A Review of the Oconee-3 Probabilistic Risk Assessment

External Events, Core Damage Frequency

Brookhaven National Laboratory

Prepared for
U.S. Nuclear Regulatory
Commission

Figure 3.10 Comparison of the 1976 and 1982 USGS studies and the mean Oconee seismic hazard curve.

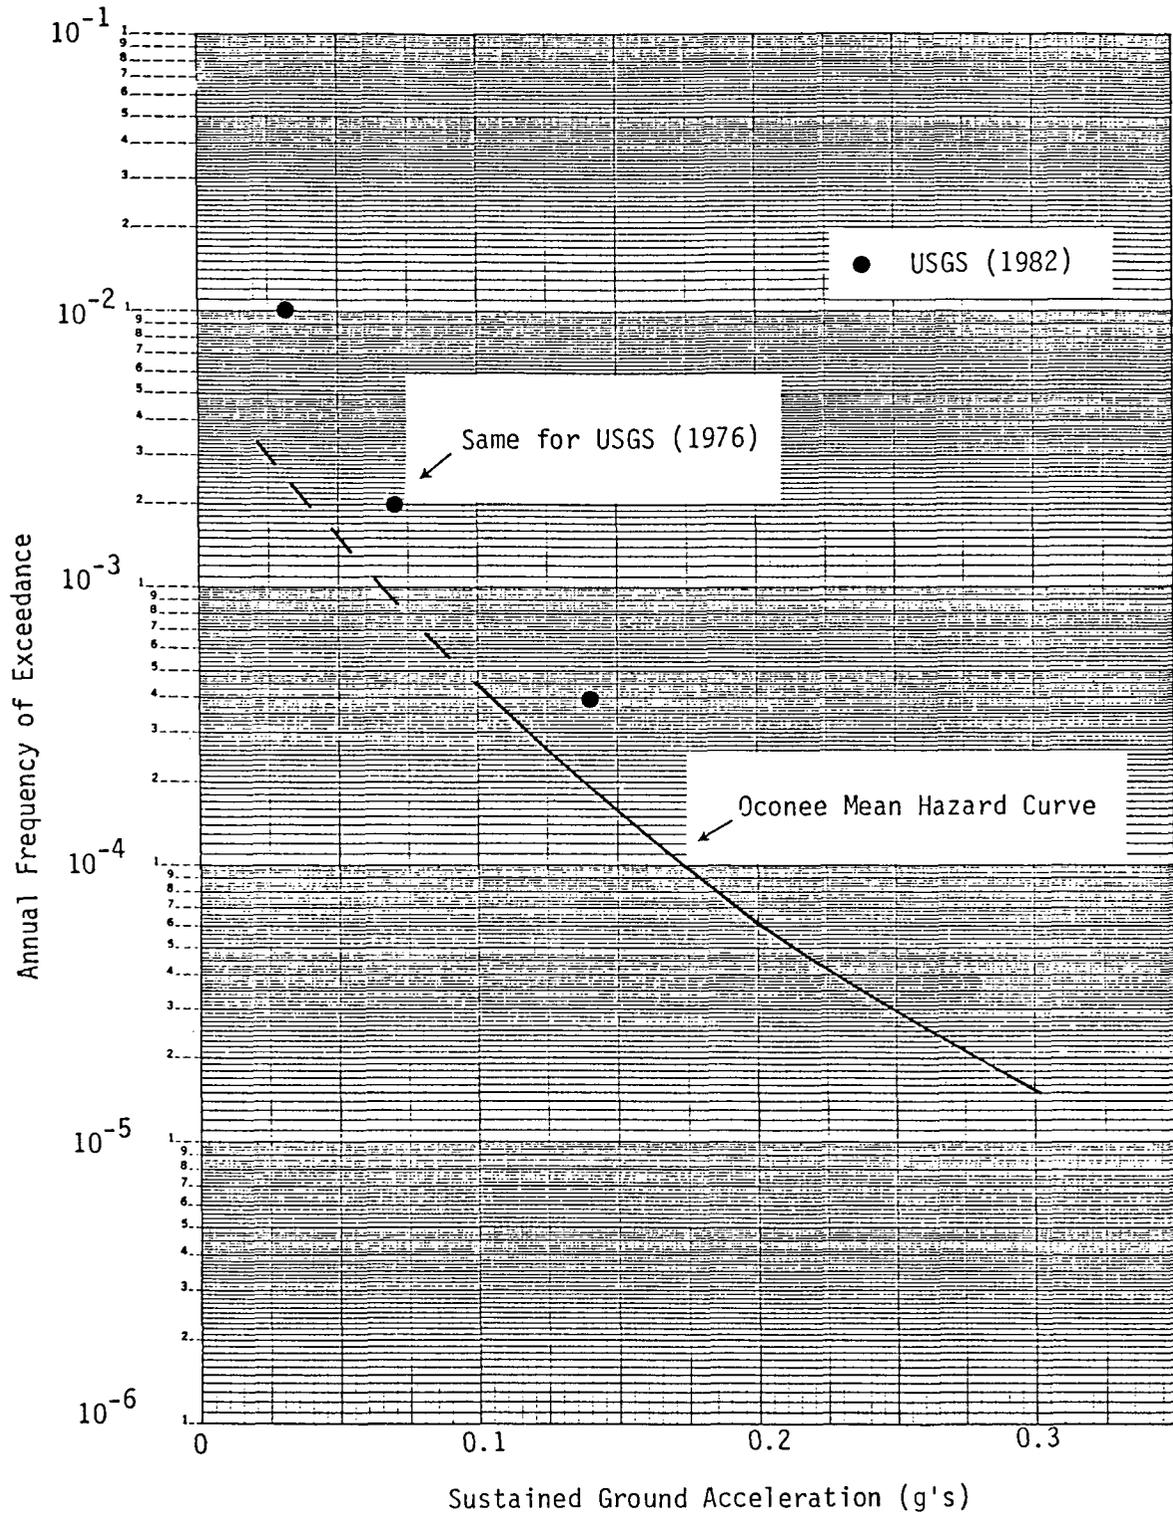
Figure 3.10 compares the USGS 1976 and 1982 hazard curves with the mean Oconee hazard curve. It is difficult to make a true qualitative comparison between these studies since the USGS studies do not account for the variability in ground motion. If they had, their results would be higher.

Figure 3.11 Comparison of cases 1 and 2.

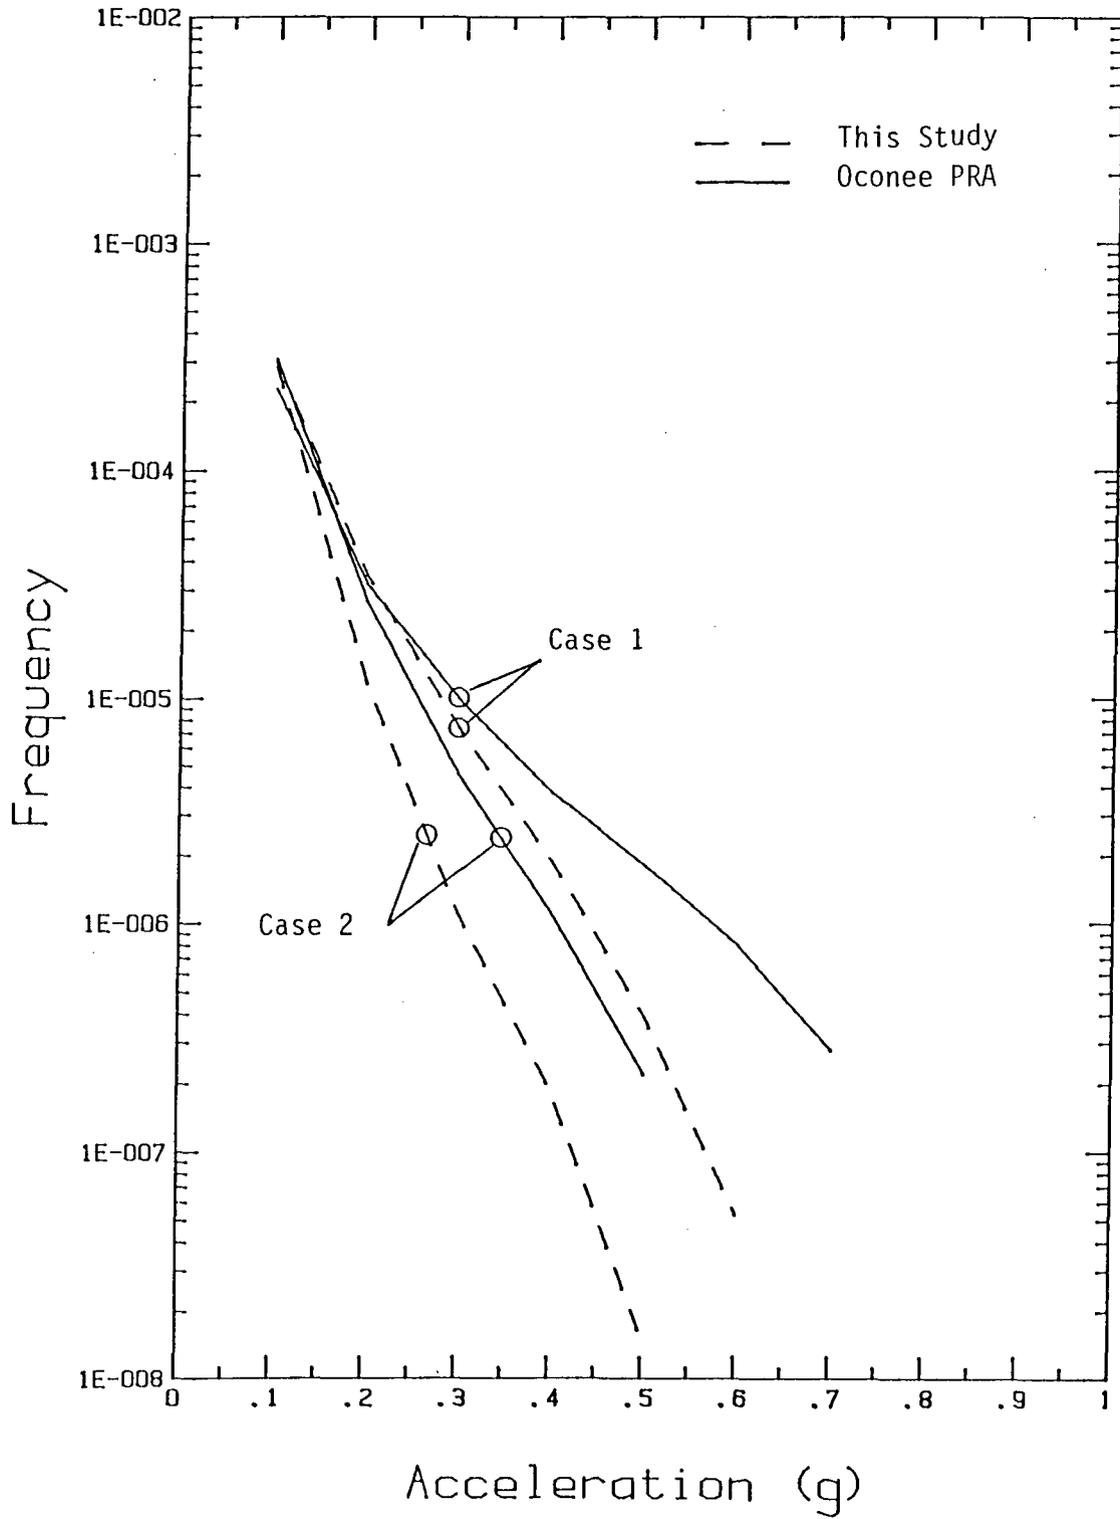
The results of our calculations and those reported in the OPRA are shown in Figure 3.11 in terms of sustained ground acceleration. From the figure it can be seen that beyond 0.40g, there are differences of greater than a factor of 2 between the two estimates for case 1 (i.e., OPRA and this study). For case 2, there is a factor of 2 difference at 0.20g's. Note that the Oconee hazard estimates are higher.

These findings were discussed with the author of the Oconee hazard analysis. In this discussion we first confirmed that the input to our calculations were correct. It is unclear, from the results reported in Figure 3.11 and our discussions with the analysts involved in the Oconee study, exactly what truncation level was used in the Oconee calculations. We understand that possibly a truncation at greater than two standard deviations was used, although this could not be confirmed. Secondly, it was learned that the seismic hazard results reported in Table 3 of the Oconee hazard report are smoothed values. The ill effects of this smoothing, which was greatest near the truncation limit, are apparent in case 1. From the results of our hazard computations, we find that only the Piedmont and Upper Coastal Plain source area contribute to the results for accelerations greater than 0.50g. Therefore, the truncation of the hazard curves is limited by the maximum intensity in this source area (i.e., MMI = VIII). From Table 3.3, the limit on acceleration is 0.681g; therefore, beyond 0.681g the frequency of exceedance should be zero. The Oconee hazard curve at 0.70g has a frequency of exceedance of $2.8E-7$, which is incorrect.

Figure 3.12 Comparison of cases 1 and 2 results using a three standard deviation truncation.

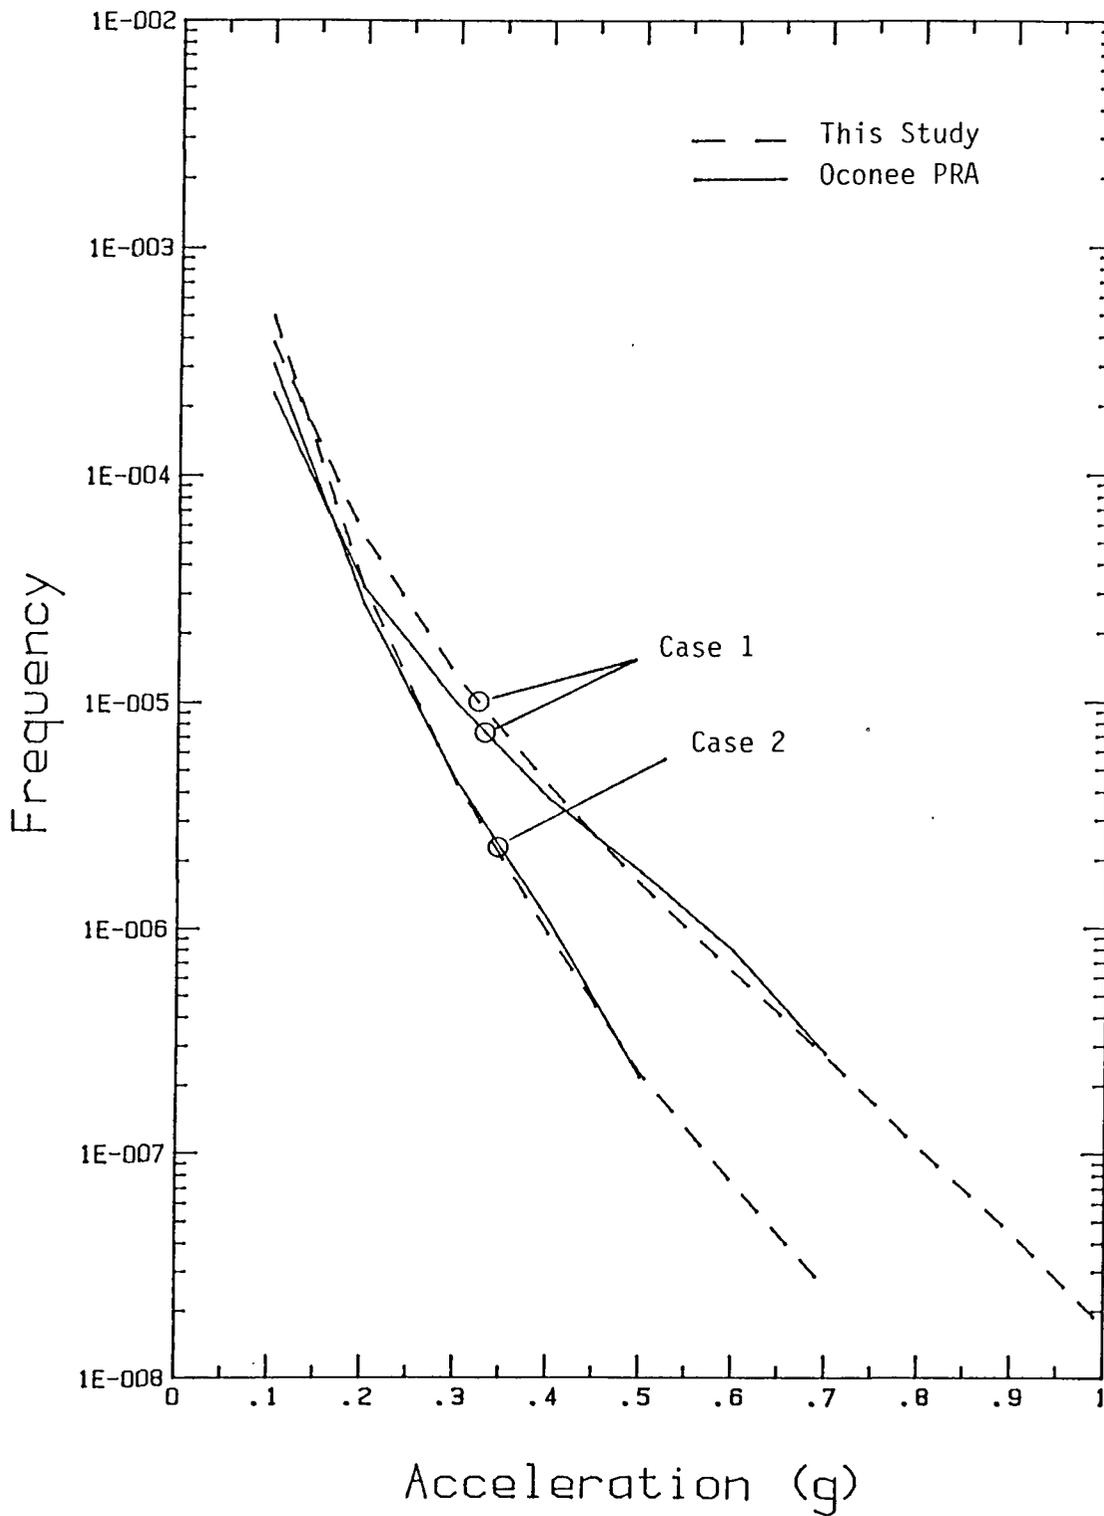
To reconcile our calculations with the Oconee results for cases 1 and 2, a three standard deviation truncation level was used. Figure 3.12 shows this comparison. For accelerations $<0.70g$, the results are reasonably close. Above 0.70g, the results are not as favorable since the truncation level is higher for a three standard deviation cutoff.

Figure 3.13 Comparison of cases 1 and 2 using a five standard deviation truncation.

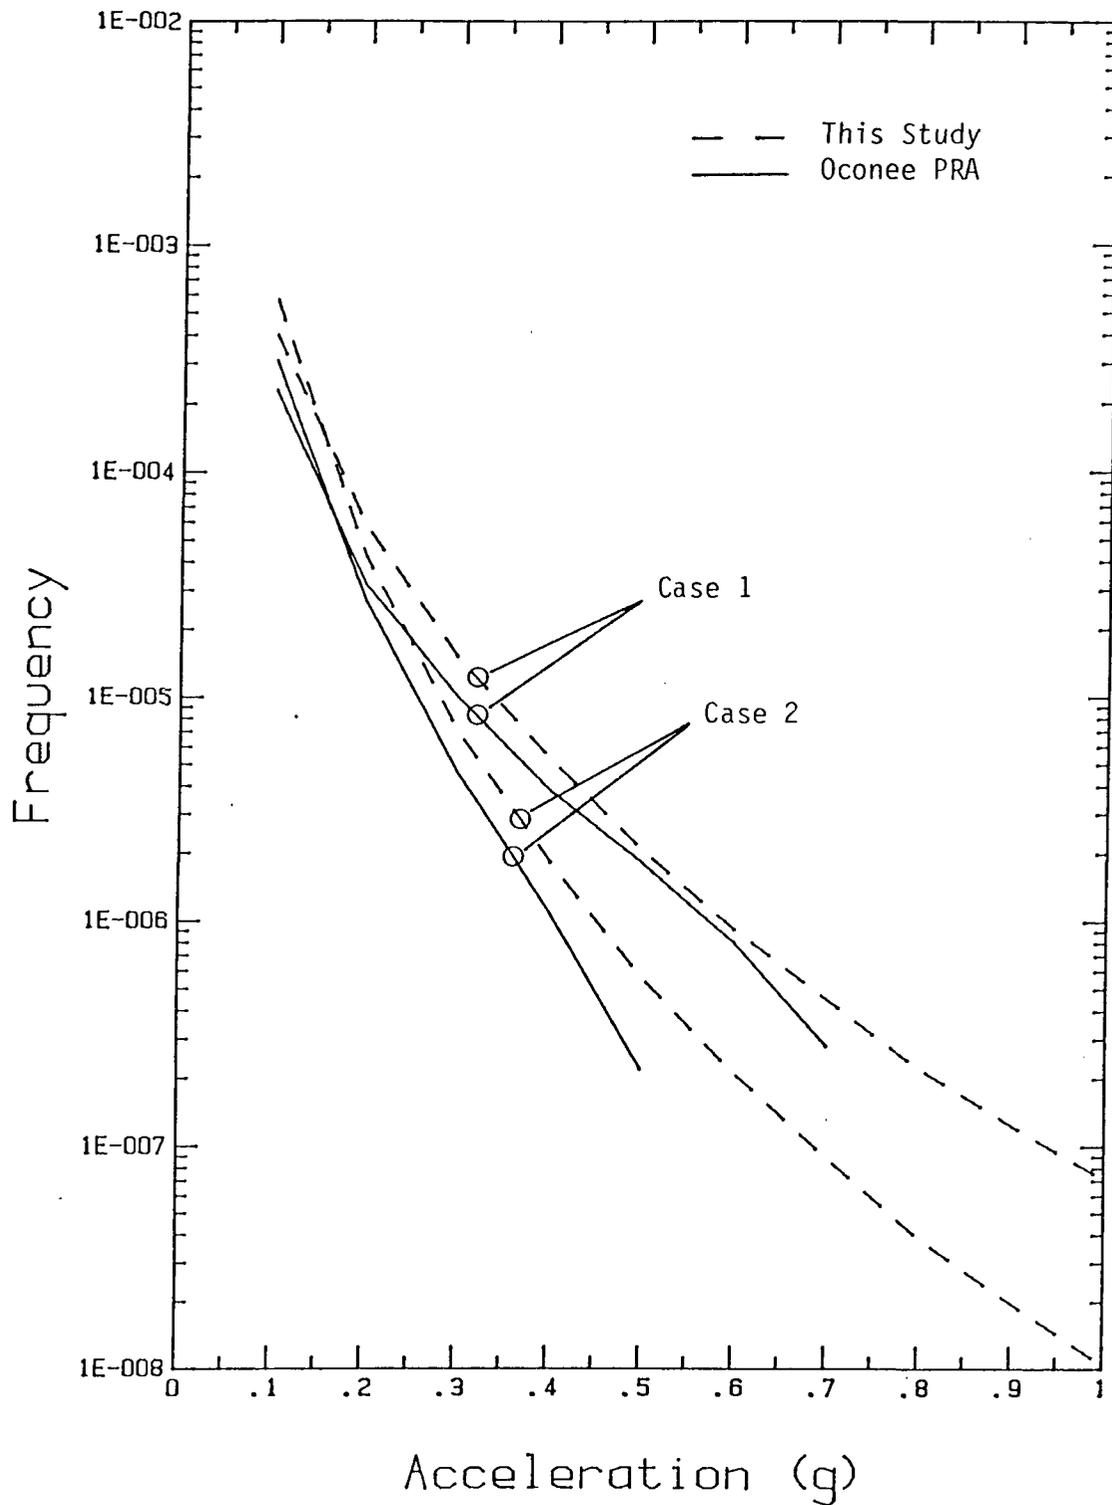
In Figure 3.13, a much higher truncation level of five standard deviations is considered for cases 1 and 2 and are compared to the Oconee results. Using a higher truncation limit produces hazard curves two to three times higher for case 1 and less for case 2. This suggests that for accelerations less than 0.40g, the effect on the hazard results of applying a truncation on acceleration is small.

Figure 3.14 Comparison for cases 1 and 2 hypothesis 1, $I_{\max} = VIII$ for the Piedmont and upper coastal plain source.

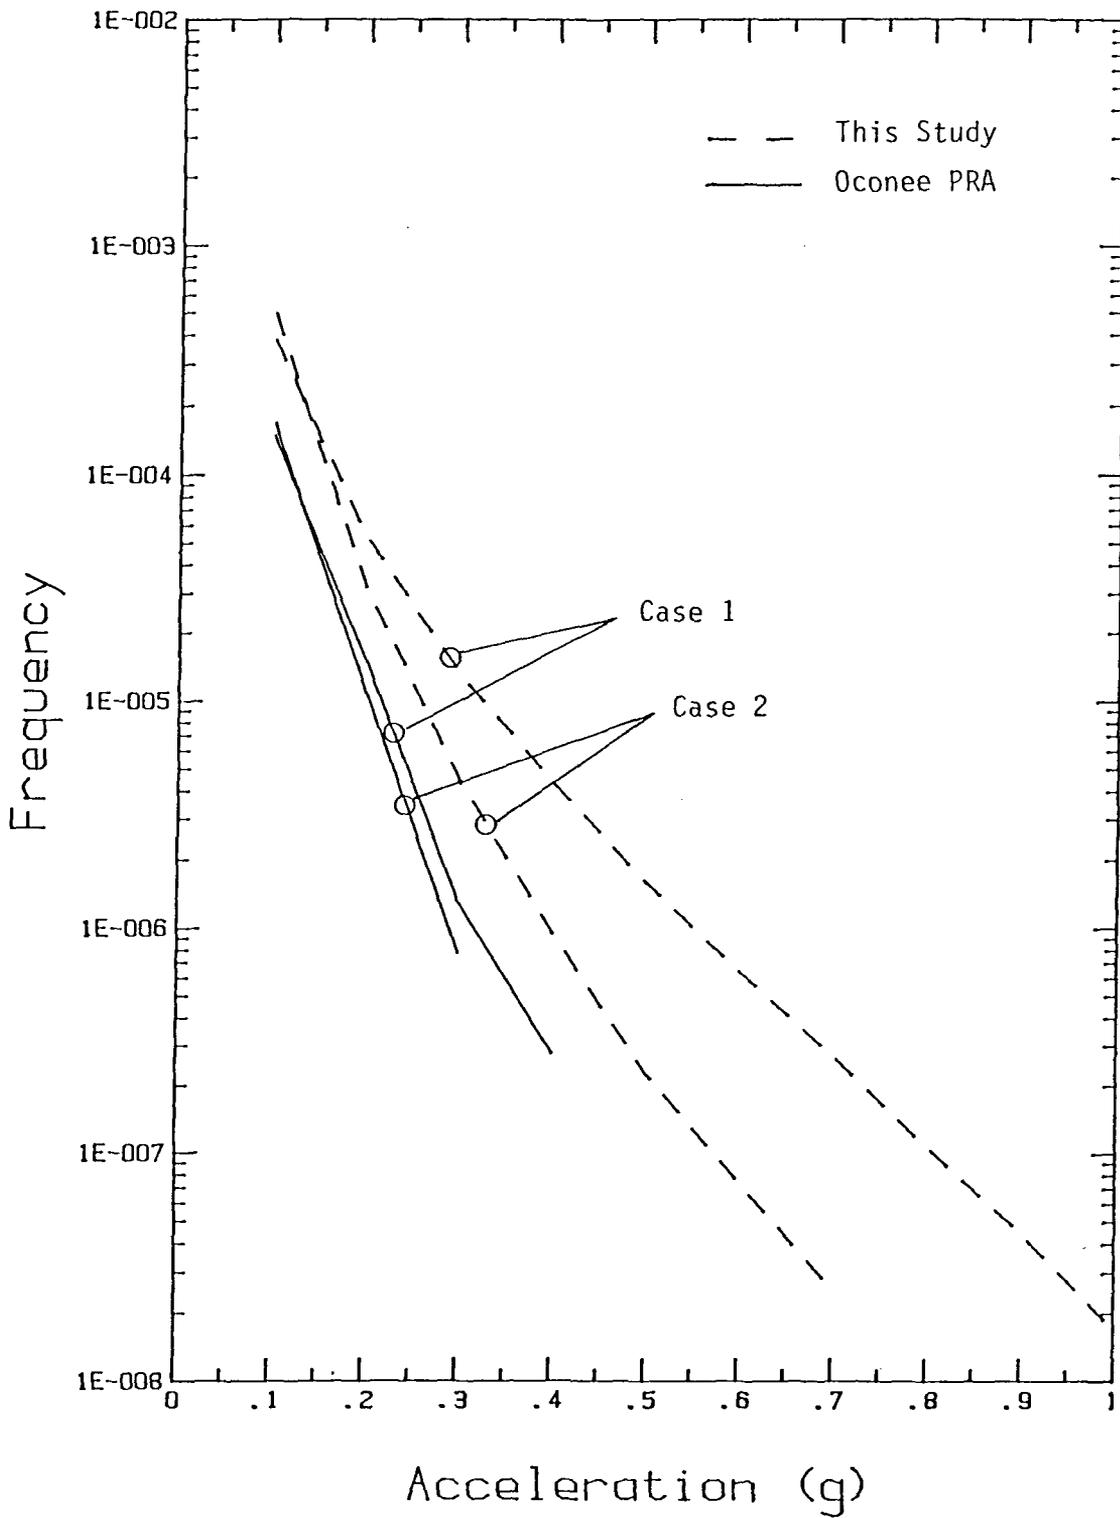
As part of our review, it was stated that the maximum intensity for the Piedmont and Upper Coastal Plain source area for all three hypotheses may be underestimated by one intensity unit. Figures 3.14 to 3.16 compare the effect of increasing the maximum intensity for cases 1 and 2, one unit for each hypothesis on the maximum size earthquake. For the Piedmont and Upper Coastal Plain source, the following revised estimates are made:

For accelerations beyond 0.30g, the difference increases to as much as a factor of 10 (see Figure 3.14). The largest differences are realized for hypothesis 1, while for hypotheses 2 and 3 the largest variations are less than a factor of 5.

Figure 4.1 OPRA cable-shaft fire event tree.

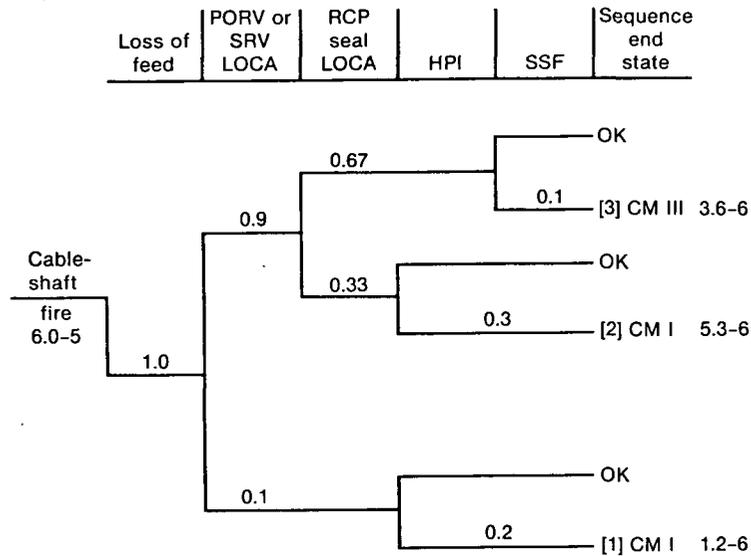
The review of the event tree and accident sequences presented in Figure 4.1 was performed by BNL and the following comments are appropriate:

1. BNL is in qualitative agreement with the fire event tree (Figure 4.1).
2. The quantification of the top event HPI, i.e., failure of the operators to indicate HPI, is based on two assumptions:
 - a. The actions to start the HPI function can be remotely performed from the control room.
 - b. The safety injection signal is not generated automatically.

For the above reasons, it is the opinion of the BNL reviewers that the probability of not having the HPIS to mitigate the LOCA (i.e., probability of failure for top event HPI in Figure 4.1) may approach 1.0 if no credit is taken for operator actions to locally open valves 3HP-24 and 3H-25. Note that the OPRA does not indicate that the operators are aware of this problem. To evaluate the failure probability for the top event HPI, a much more detailed analysis would be necessary. Therefore, this review will use the probability equal to 1.0 (i.e., certainty) for the top event HPI as an upper bound, noting that this value may not necessarily be a very conservative assumption.

Figure 4.2 OPRA event tree for sequences initiated by a severe tornado.

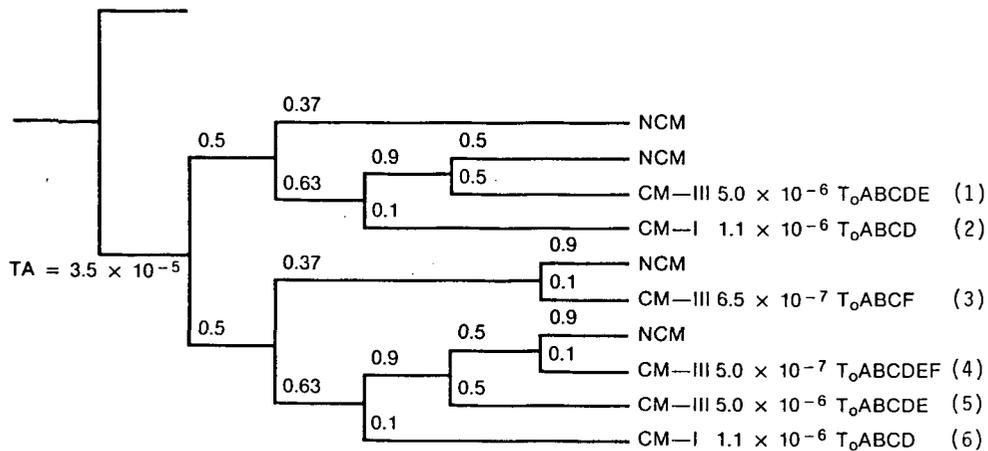
- Using the assumptions above, BNL reviewed the event tree. It is the reviewers' opinion that given a loss of 4-kV power (event B in Figure 4.2), seal leakage will occur (loss of makeup and loss of component cooling). Thermal barrier cooling is lost when component cooling is lost. Additionally, seal injection fails because HPI is not available (loss of 4-kV power and loss of BWST) and because the possibility of makeup from the SSF is also lost as the result of tornado damage to the west penetration room (see OPRA page 9-60, event F). Implications of these failures have been discussed in internal events treatment, where it is shown that core damage will occur in several hours. Note that loss of the BWST means that the seal LOCA cannot be mitigated

even if 4-kV power is restored before core uncover. Therefore, sequences 3 through 6 in Figure 4.2 are substituted by the sequence T₀AB, which is a bin I sequence with a frequency equal to 1.7×10^{-5} /yr. The following revised core damage frequencies are then obtained:
